motionarchitecture t: +44 (0)759 007 7000 e: suraj@motionarchitecture.com 155 Carlton Avenue East, HA9 8PU			
Denewood, Chorleywood Road, WD3 4EP SCALE: 1:1250 @A4 DWG NO: DW_001 REV: 02 DATE: FEB 2025			
This drawing is copyright		Do Not Scale	All dimensions to be checked on site

Denewood, Chorleywood Road, WD3 4EP
SCALE: 1:200 @A3 DWG NO: DW_020 Proposed ground floor plan
REV: 01 DATE: FEB 2025

Proposed first floor and roof plans
REV: 02 DATE: JULY 2025

Ordinance survey site plan 1:1250

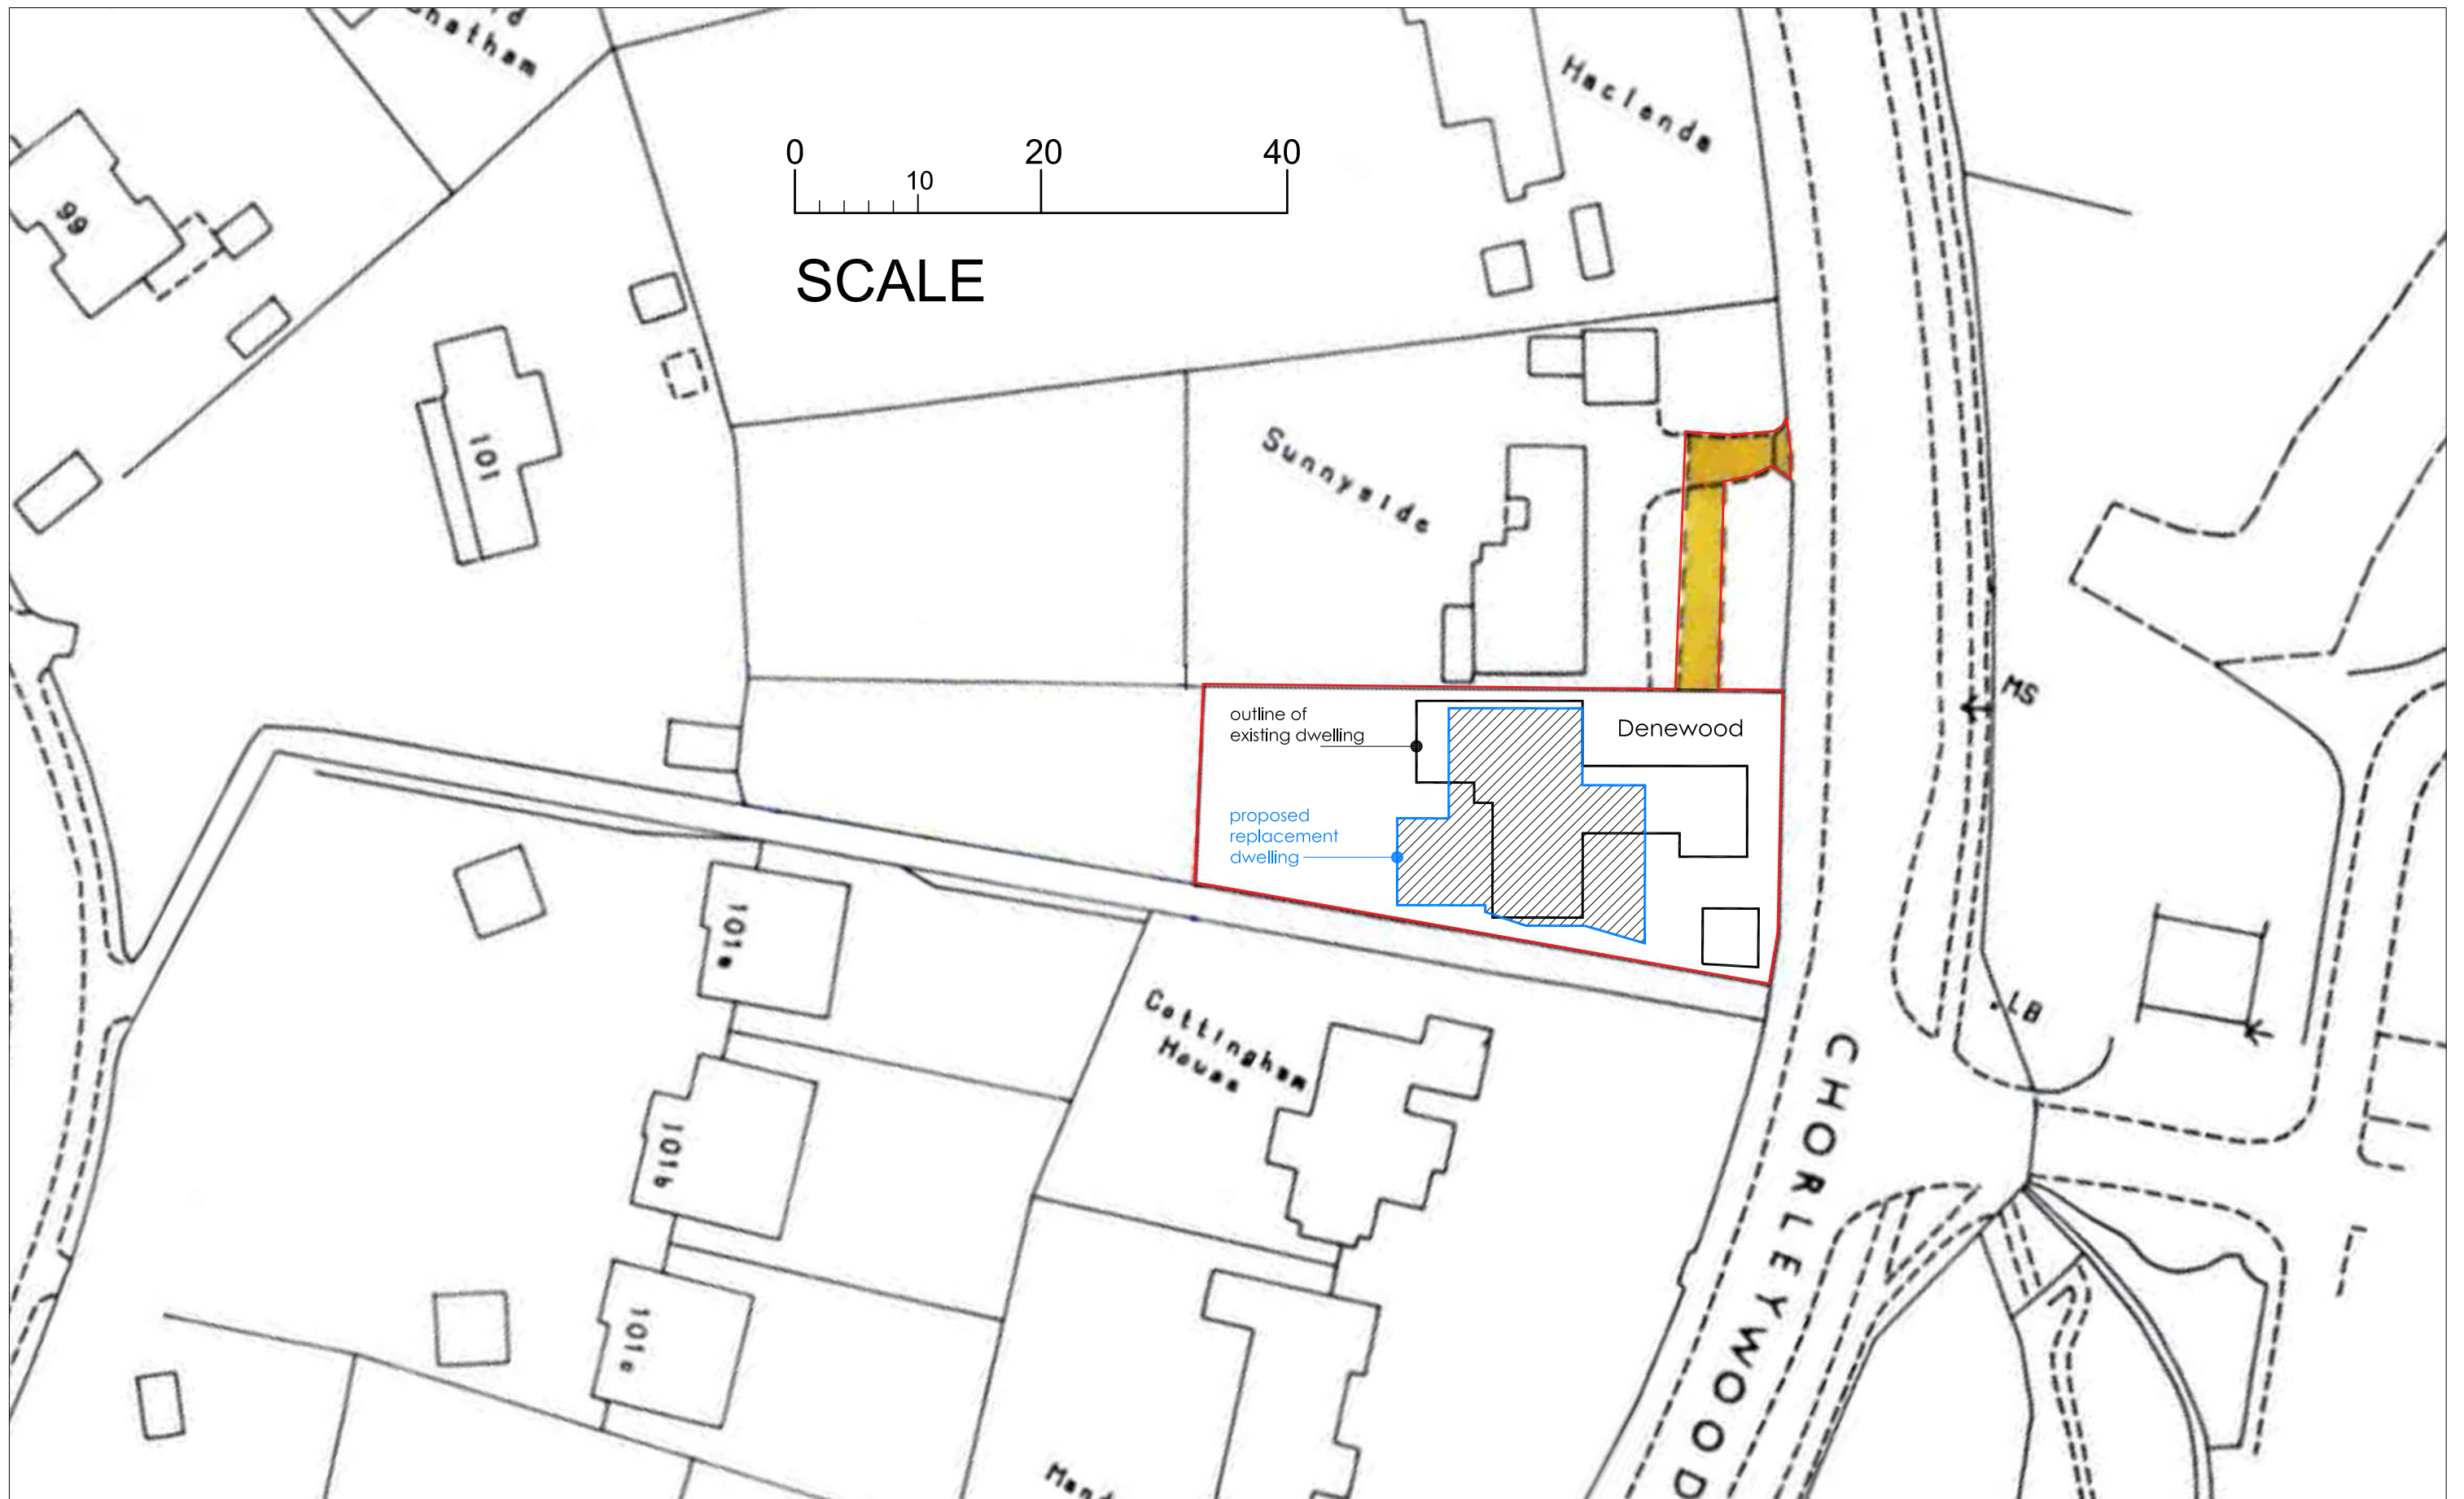
rev02:18.03.25 - redline further modified and image cleaned up after planner's comments.
 rev01:12.03.25 - redline added to shared driveway after planner's comments.

Block plan 1:500

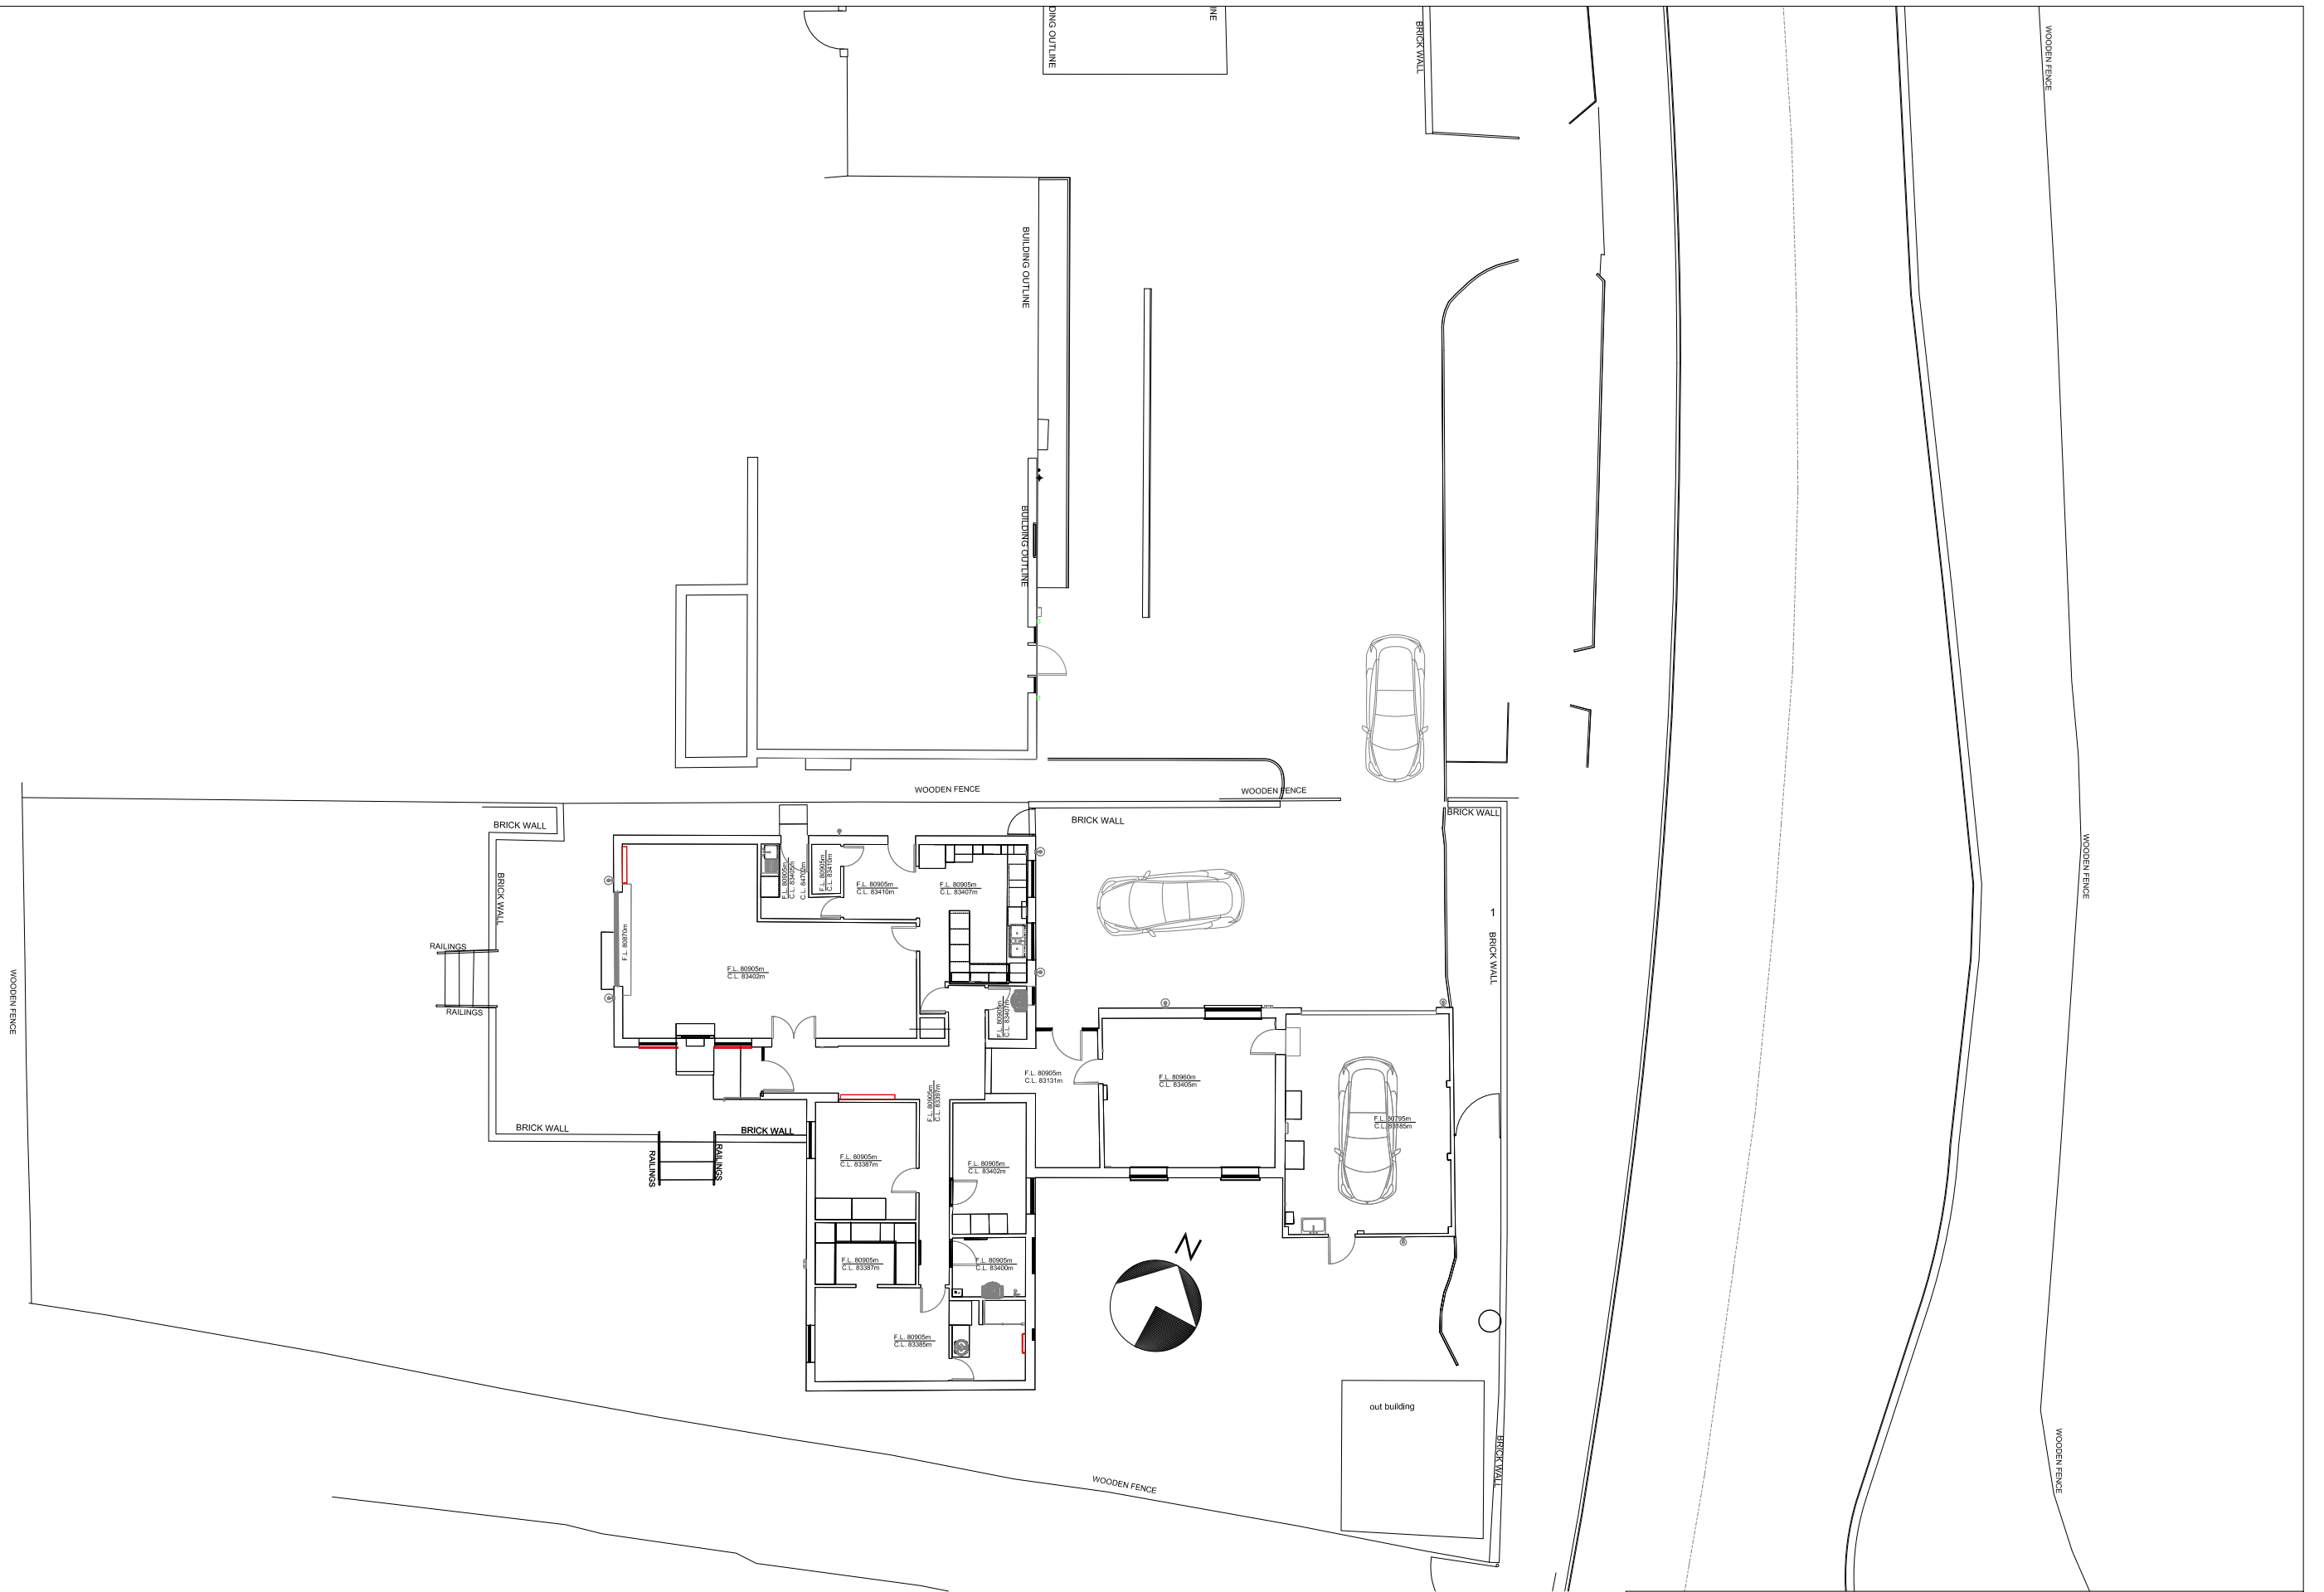
rev02:18.03.25 - redline further modified and image cleaned up after planner's comments.
rev01:12.03.25 - redline added to shared driveway after planner's comments.

Proposed Ground Floor Plan

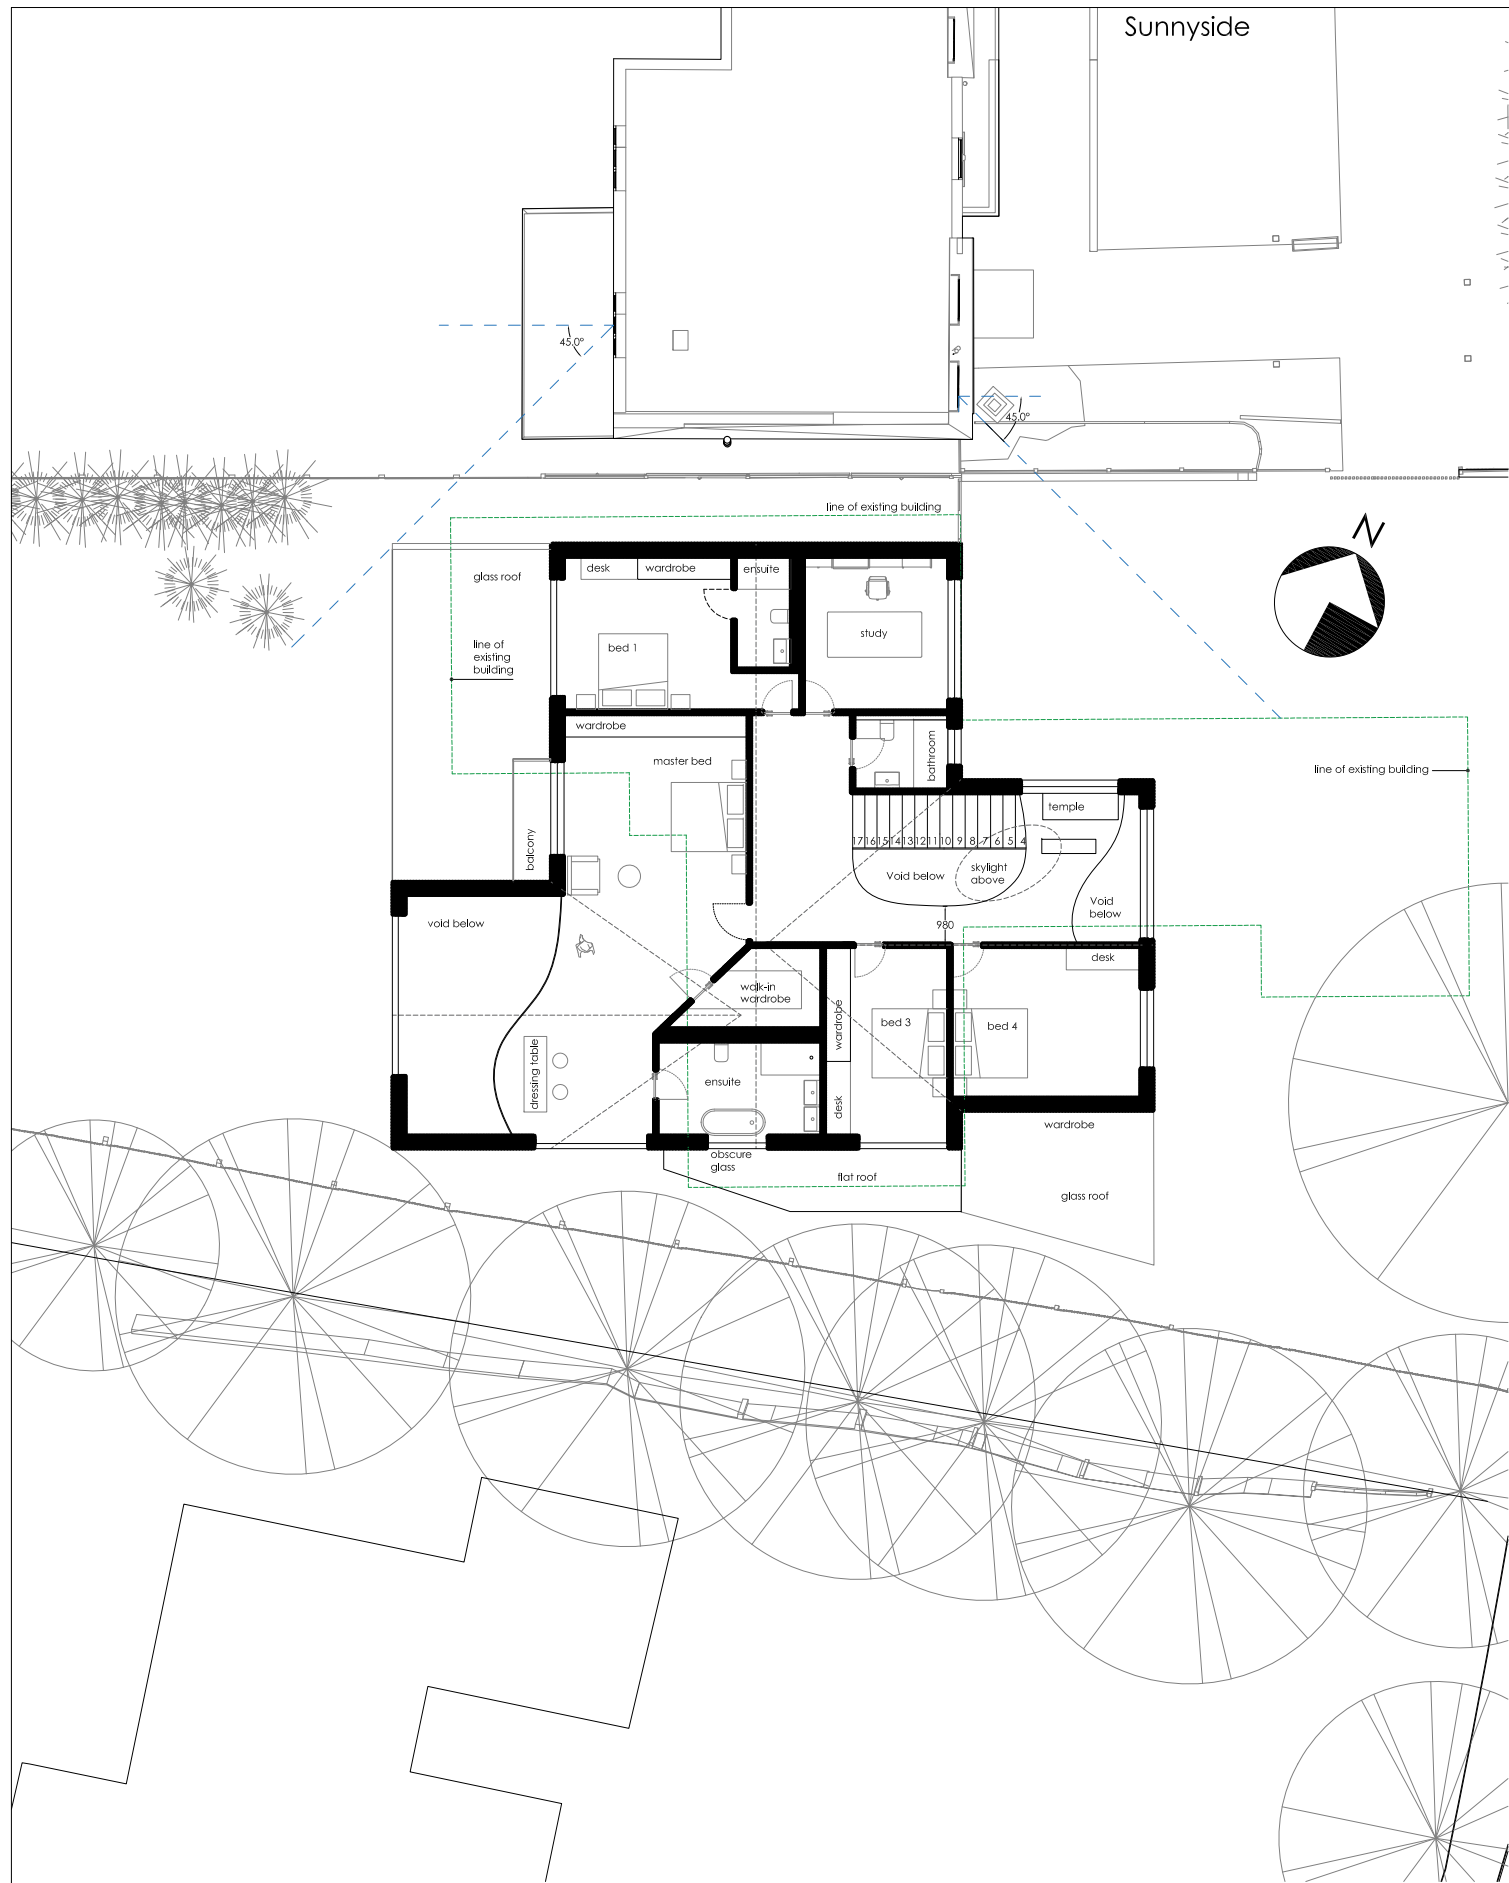
Rev 01:14/02/2025 - Side elevation balcony omitted & rear balcony added based on planner's comments.
